Title		
SCR control		
Size	Document Number	Rev
B	Replacement for BG 522 225GU	A
Date:	Wednesday, June 06, 2007	Sheet 1 of 1

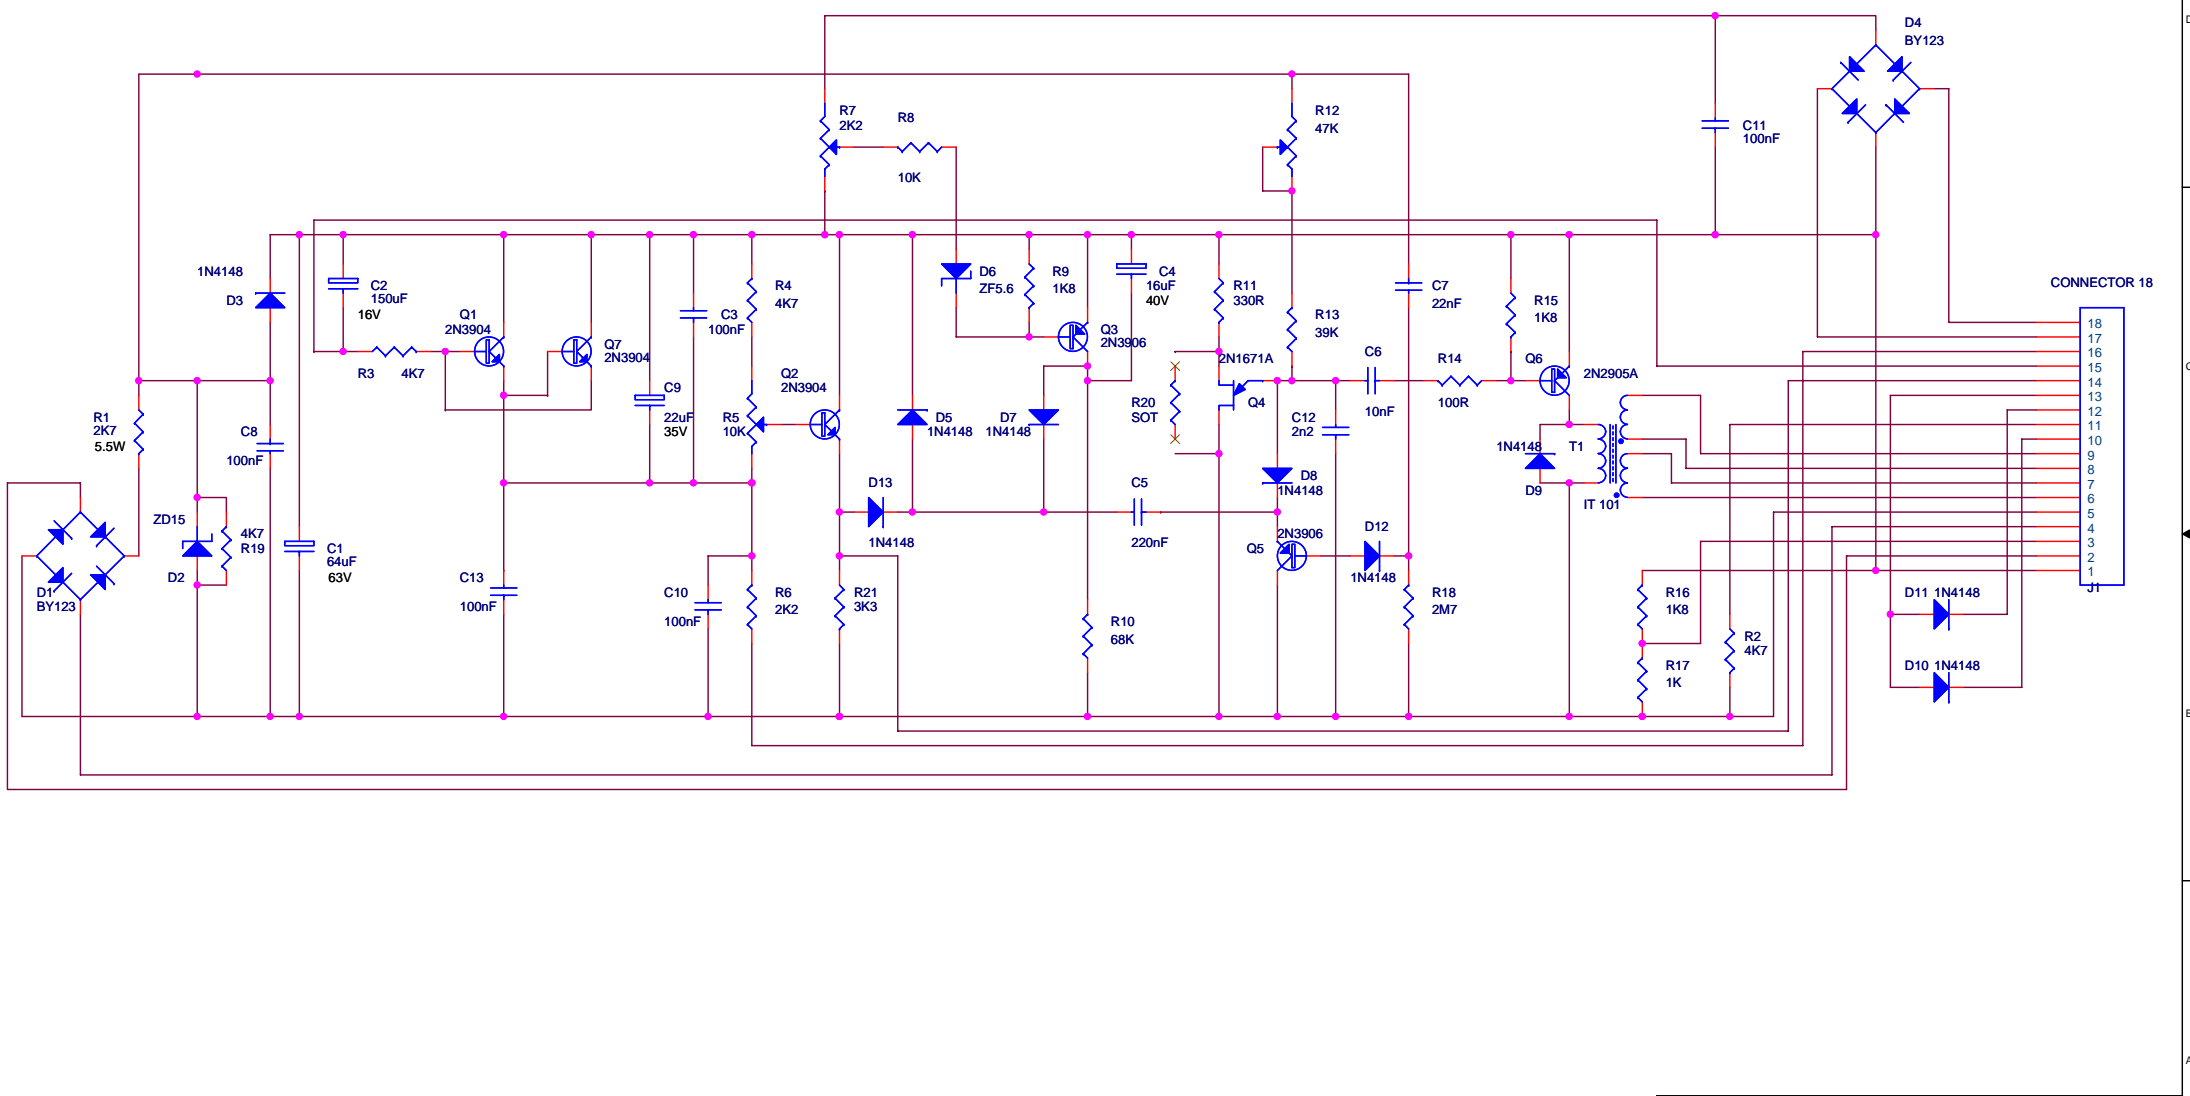
Notes:  
 R13 originally 27K, actual = 39K

C8 has space but not fitted  
 C9 has space but not fitted (was mounted vertically)  
 C12 new component  
 C13 new component
